HISTORIC DISTRICT COMMISSION OF WASHINGTON COUNTY, MARYLAND

AGENDA

September 3, 2025

Subj: Residential Addition-Alteration Permit/Solar Panels, 2025-03697

Solar Panel Layout

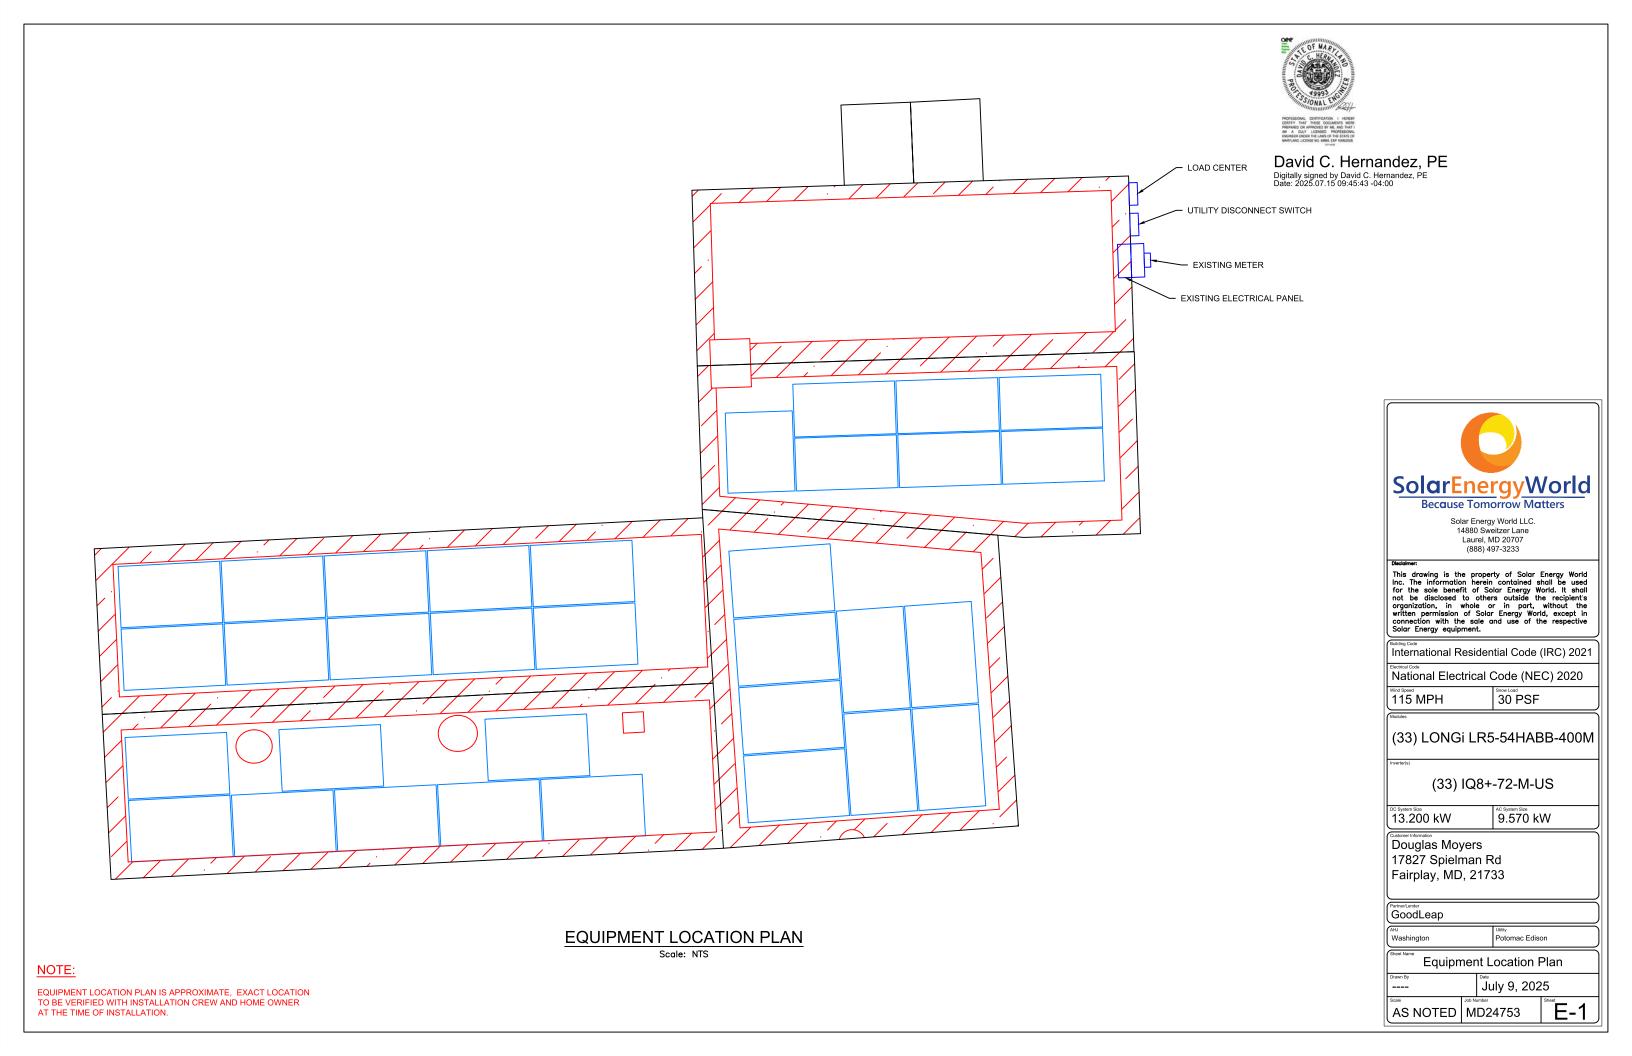
The permit application is for the installation of (33) 13.20 kW roof mounted solar panels on the dwelling on two rear roof sections of the two-story main portion of the dwelling and one streetside elevation for the single-story wing as well as its rear elevation. While undated, the wing to the side is an enclosed breezeway to a single car garage and is constructed of asphalt shingles while the main portion

has a deteriorated metal roof. The application document does note a need for a new metal roof prior to installation of the panels.

The proposed solar panels are at a low profile with the mounts indicating they are 4.68-6" in height. No changes are proposed in the slope of the roof. Equipment for the panels appears to be placed near existing utility meters to the east side of the structure. The panels are a dark color similar to existing roofing materials. The panels visible from the right-of-way are symmetrical and joined in a way to not have any gaps in panels. The panels visible from the right-of-way, while placed on the single-story structure will have minimal visibility to the majority of the structures contributing to this rural village due to its setback from the road and subordinate position to the main two story portion of the structure. The panels with visibility from the right of way are also placed on the single-story portion which appears to be more modern and less impactful to the historic portion of the structure. The panels meet most County guidelines regarding solar placement for these reasons. Their placement does not conflict with review criteria under Article 20 or Section 5D.5 of the zoning ordinance.

Recommend approval of the Residential Addition-Alteration Permit/Solar Panels, permit number 2025-03697, in Fairplay Historic Rural Village for the reasons stated in the Staff Analysis.
